SUBJECT: H. B. ROBINSON STEAM ELECTRIC PLANT, UNIT NO. 2 – ISSUANCE OF
AMENDMENT TO REVISE REACTOR COOLANT SYSTEM PRESSURE AND
TEMPERATURE LIMITS APPLICABLE FOR 50 EFFECTIVE FULL POWER
YEARS (CAC NO. MF7048)

Amendment No. 248
Renewed License No. DPR-23

SAFETY EVALUATION BY THE OFFICE OF NUCLEAR REACTOR REGULATION

Figure 3.4.3-1
Reactor Coolant System Heatup Limits
Applicable Up to 50 EFPY

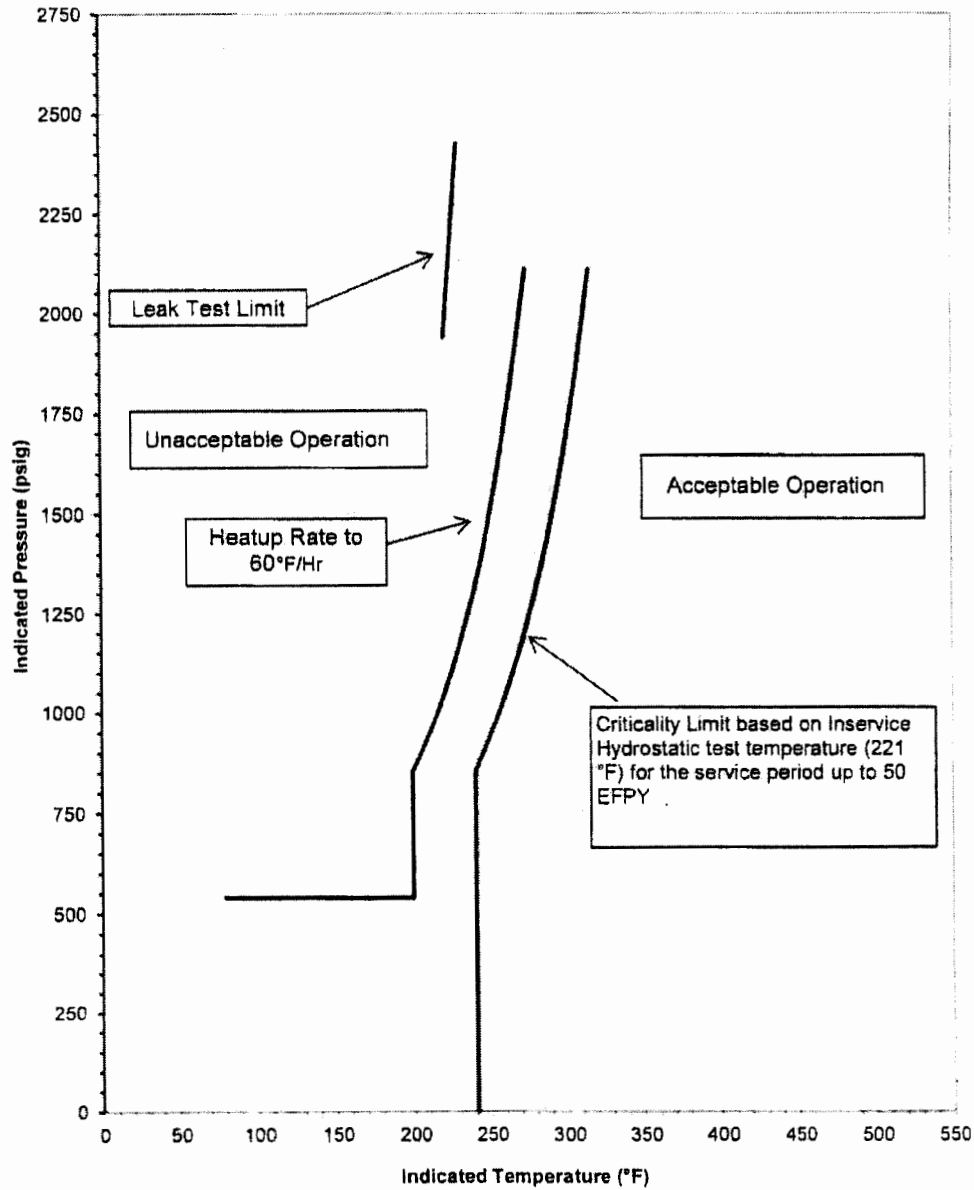
The U.S. Nuclear Regulatory Commission has issued the enclosed Amendment No. 248 to Renewed Facility Operating License No. DPR-23 for the H. B. Robinson Steam Electric Plant, Unit No. 2 (HBRSEP2). This amendment changes the HBRSEP2 Technical Specifications (TSs) in response to your application dated November 2, 2015, as supplemented by letters dated December 22, 2015; and March 31, May 9, and September 14, 2016. The amendment revises the reactor coolant system (RCS) pressure and temperature limits by replacing TS Section 3.4.3, "RCS Pressure and Temperature (P/T) Limits," Figures 3.4.3-1 and 3.4.3-2, with figures that are applicable up to 50 effective full power years.

SR 3.4.3.1 verifies that that RCS operation is within the limits of Figures 3.4.3-1 and 3.4.3-2 when RCS pressure and temperature conditions are undergoing planned changes. The LAR extends the applicability of the P-T limits to 50 EFY, which does not impact the function of SR 3.4.3.1 to verify that the RCS is operated within approved P-T limits. Therefore, the NRC staff finds the use of the revised Figures 3.4.3-1 and 3.4.3-2 in SR 3.4.3.1 meets 50.36(c)(3) by providing sufficient test, calibration, or inspection requirements to assure that the necessary quality of systems and components is maintained, that facility operation will be within safety limits, and that the LCOs will be met.

Curves applicable for heatup rates up to 60°F/Hr for service period up to 50 EFPY
Heatup Curves include +20°F and -80 psig Allowance for instrumentation error.
